- ST9 S/N 150-3036: SLB fluid end block
- UTEX Hard/Soft Combo Packing Part # 2108-23-0101-67
- UTEX Soft Packing Part # 2108-21-0101-68

MFR: ST9 Gas & Oil LLC

MODIFICATION:

Pic 1
UTEX Packing Set with o-ring

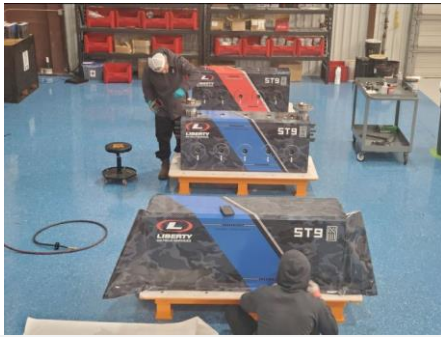
- 1) Fluid end grease port moved to facilitate greasing of new packing style.
- 2) O-ring added to lantern ring on packing to seal.
- 3) FE block comes with (2) 3" flanges instead of (1) 2" flange and (1) 3" flange.

DETAILS: SLB currently uses oil to lubricate plunger packing instead of grease. Since oil is much thinner, an o-ring was added on the SLB style packing to improve packing bore sealing and eliminate oil leaking from packing nut threads (pic 1).
